PEUGEOT/CITROËN THERMOSTAT REDESIGN TO OVERCOME OVERHEATING ISSUES

Issue Date: 23/09/19 Issue Number: COTB0024B

APPLICATION: Citroën C4, DS3, DS4, DS5, Peugeot 207, 208, 308, 3008, 5008, RCZ

APPLICABLE REFERENCES: BBT100 / BBT486

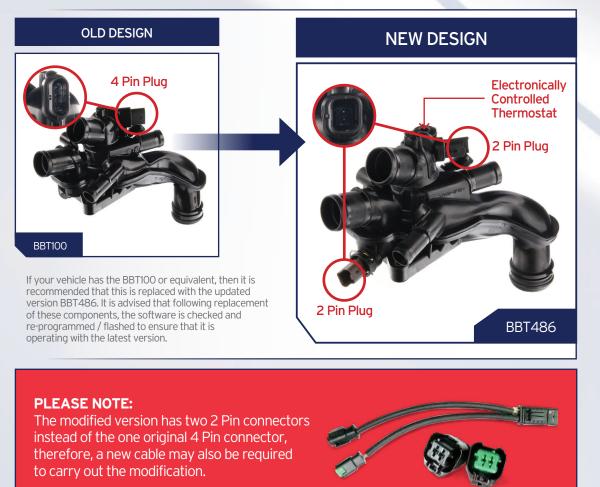
Due to an increase in overheating issues & symptoms such as an erratic temperature gauge, erratic running, radiator fan run-on, or poor heater function in the above vehicles, the O.E.M. have modified the design of the Thermostat housing. Following the O.E. specification, we have replaced the old design BBT100 with the new latest design BBT486. The latest design benefits from an electronically controlled thermostat, a reinforced structure, and a new configuration of sensors.

We have highlighted the key differences below so that you are clear that the latest part, although visually different to what may be on the vehicle, is in fact the correct product.

New Cable: BTS3091 - Thermostat Wiring Harness
